SERVICE BULLETIN

NOMAD 24 SERIES AIRCRAFT HIGH IMPACT WINDOWS FITTED TO FWD CABIN WINDOWS AT STA 150.0 (N464)

Figure 1 Templates for Manufacture of Cabin Window Gasket

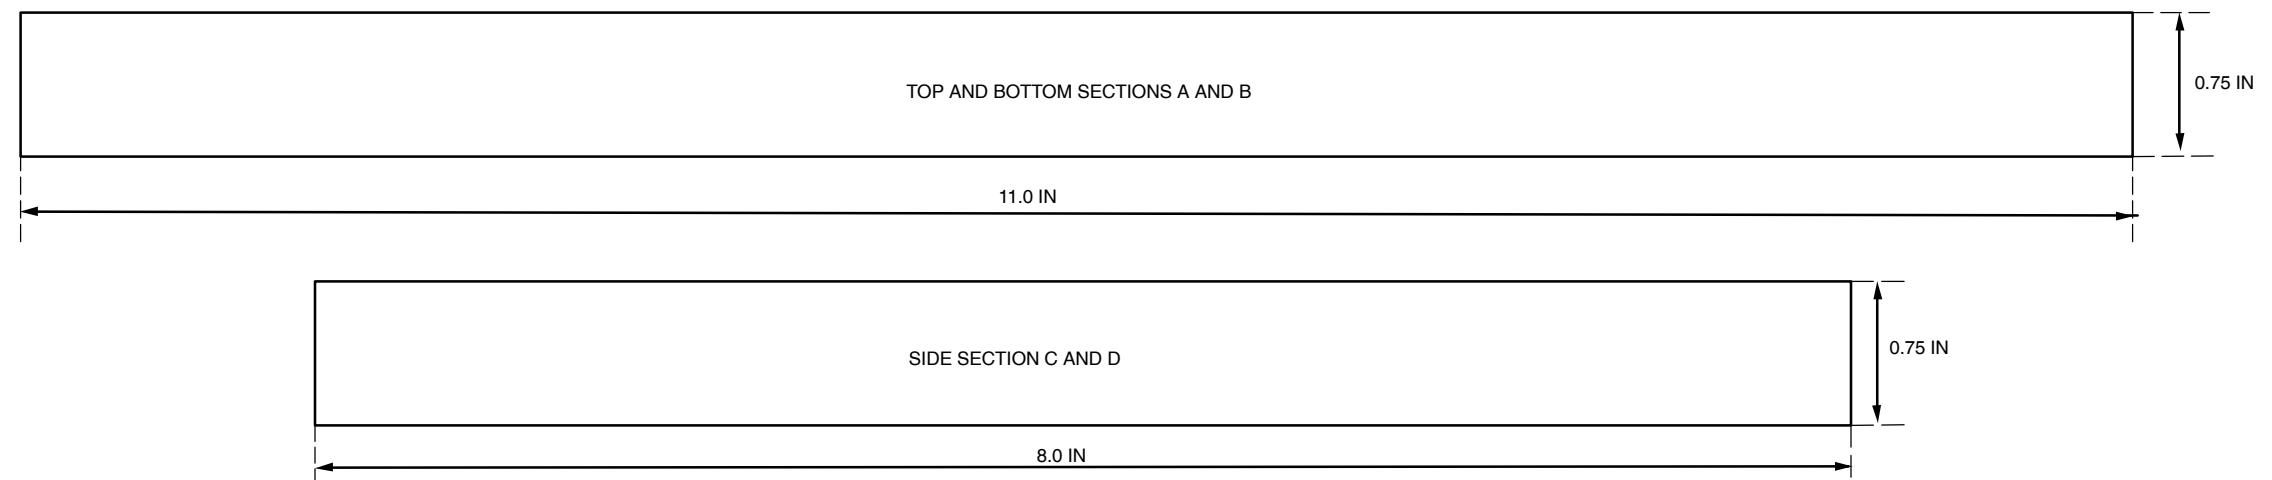
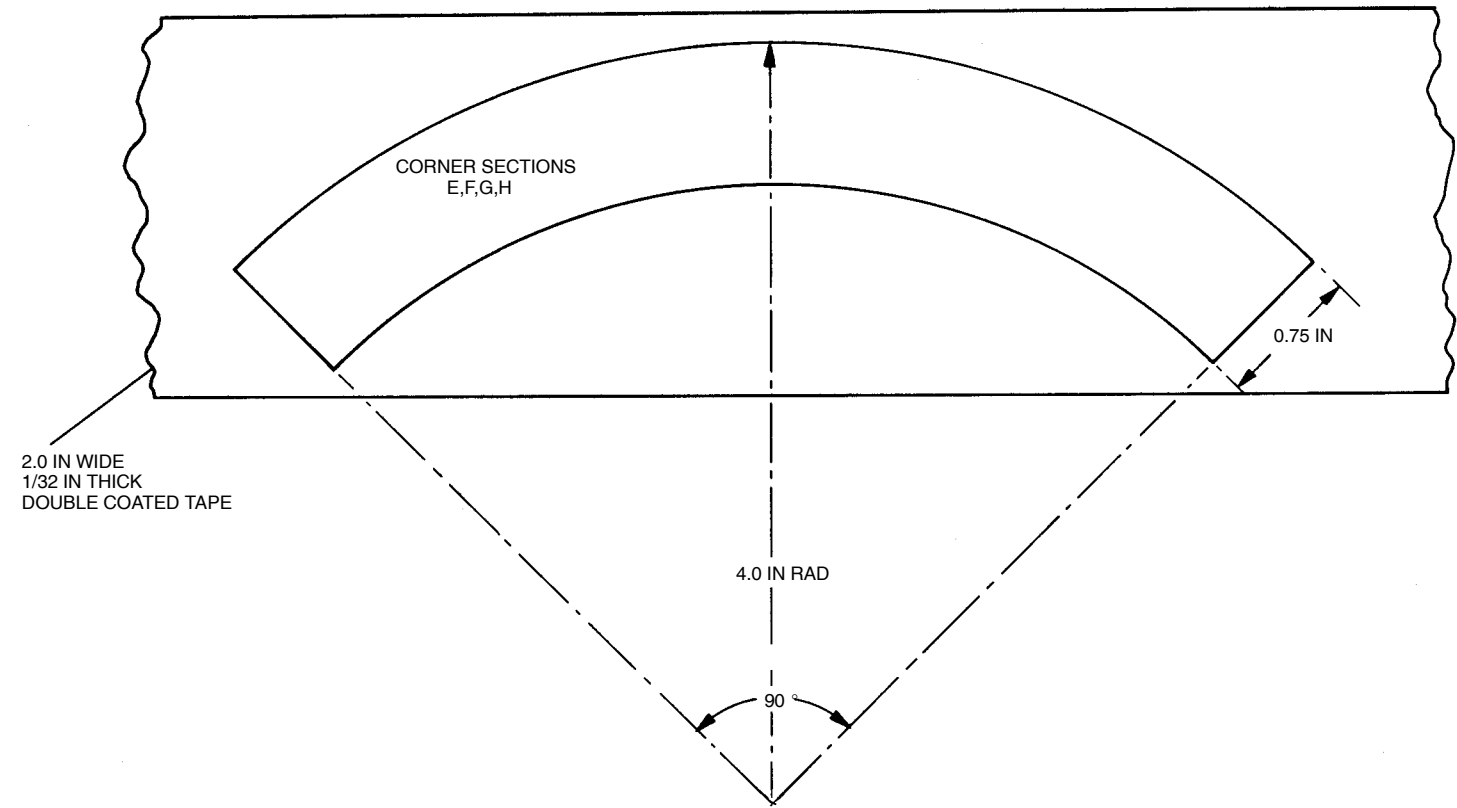
Double sided adhesive gaskets are manufactured from PN 4032 Scotchmount double coated adhesive tape 2 inches wide and 1/32 inch thick using the templates in Figure 1.

NOTE: MANUFACTURE ALL SECTIONS FROM
MMM'S SCOTCHMOUNT DOUBLE COATED
TAPE 4032

Figure 2 Window Installation

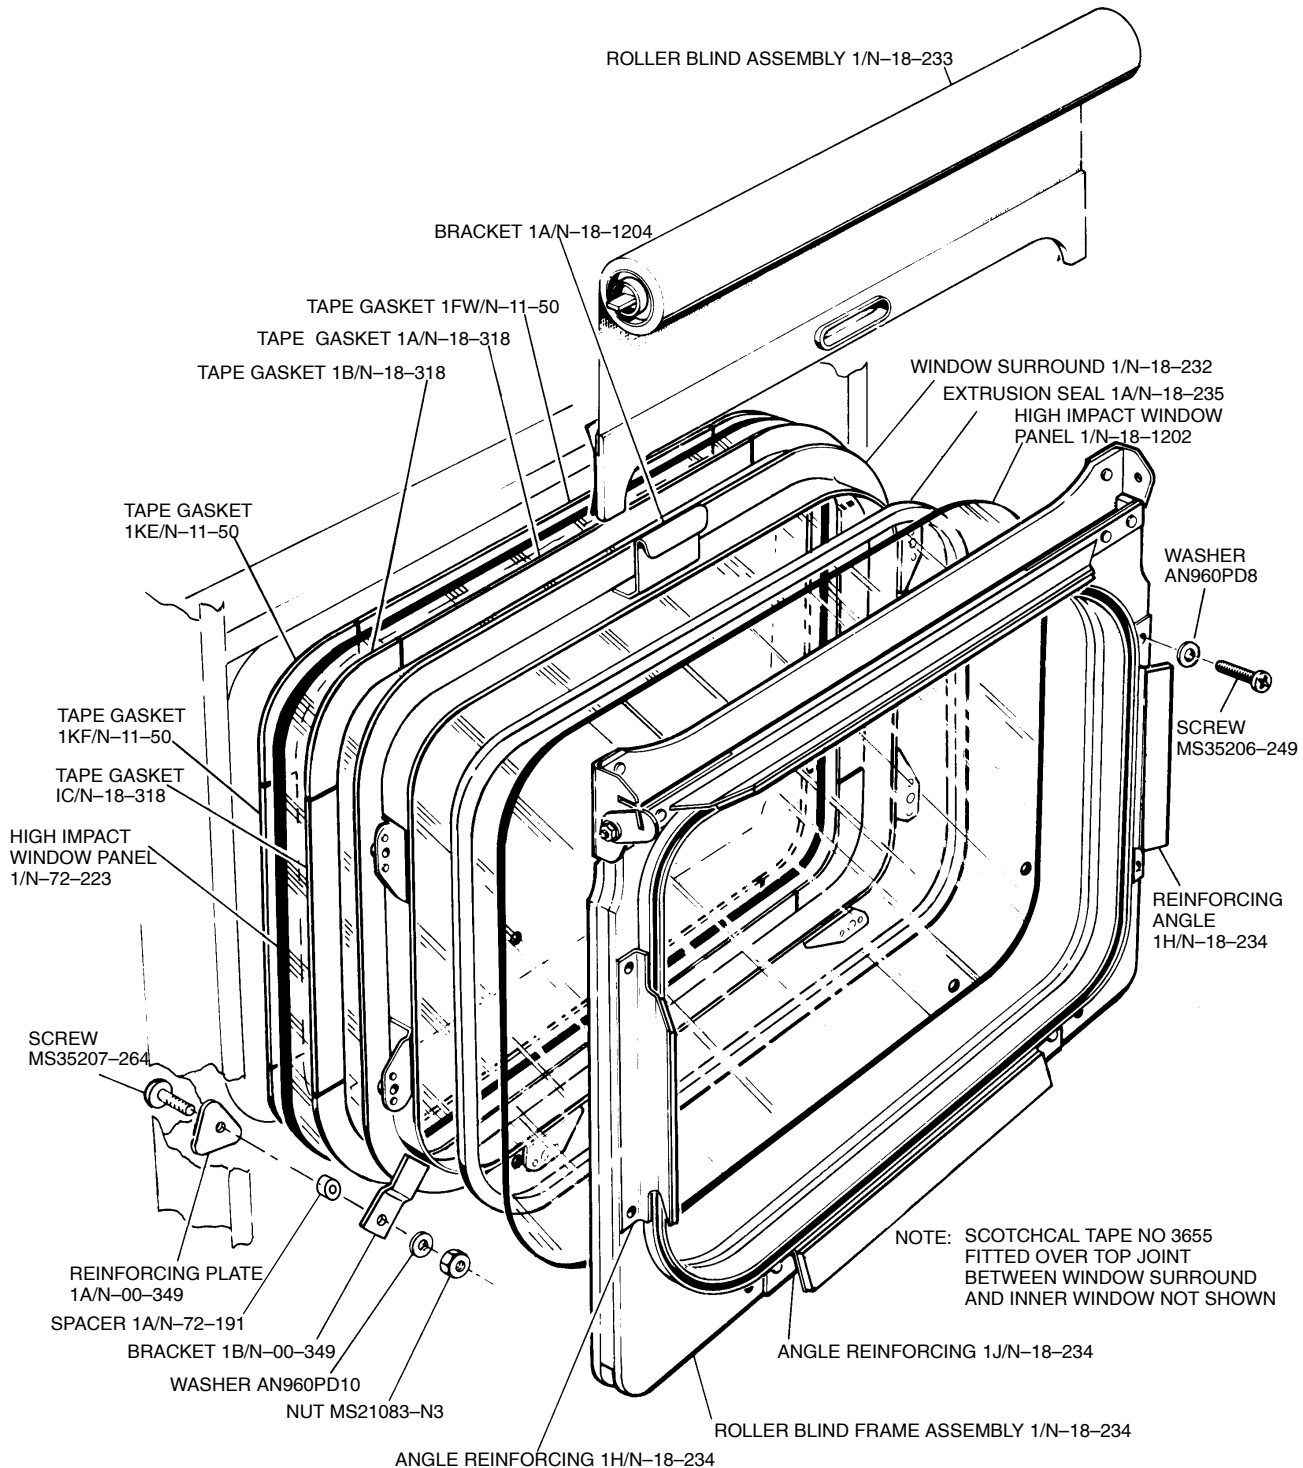
The forward outer passenger cabin windows at Sta 150.0 are replaced by windows made of 0.25 inch thick, clear high impact resistant polycarbonate material. The forward inner windows are replaced by windows made of the same material 0.125 inch thick.

B. Install the High Impact Polycarbonate Windows (Ref Figure 2)

- (1) Drill out the two rivets attaching the hook bracket PN 1D/N-18-232 to the top of the window surround, remove and discard the hook bracket.
- (2) Locate the new bracket PN 1A/N-18-1204 over the existing rivet holes in the window surround, drill holes in the bracket from the rivet holes in the window surround using a No.30 drill. Remove the bracket from the window surround and deburr the holes. Relocate the bracket on the window surround and rivet up using rivets PN MS20426AD4-4.

- (5) Remove the protective paper from the other side of the gaskets, align the new high impact polycarbonate outer window panel with the position marks on the inner surface of the fuselage skin and apply firm pressure around the edges of the window panel and the window aperture to ensure satisfactory adhesion of the window panel to the fuselage skin.
- (6) Apply a fillet of PR1221B or PR1222B sealing compound around the external joint between the fuselage skin and the outer window panel. The fillet is not to extend more than 1/16 inch beyond the edge of the skin onto the window panel.

- (7) Clean the internal surface of the outer window panel.
- (8) Secure the window surround to the outer window panel by removing the protective paper from one side of the double sided adhesive gaskets and pressing them firmly in position on the outer face of the window surround. Remove the protective paper from the other side of the adhesive gaskets and then press the window surround firmly into position on the outer window panel, ensuring that good adhesion is obtained. Using the brackets, new screws, washers and new self-locking nuts (Ref Service Bulletin NMD-56-4), secure the window surround and the outer window panel to the fuselage skin. Torque tighten the self-locking nuts to between 12 and 15 pound inches.
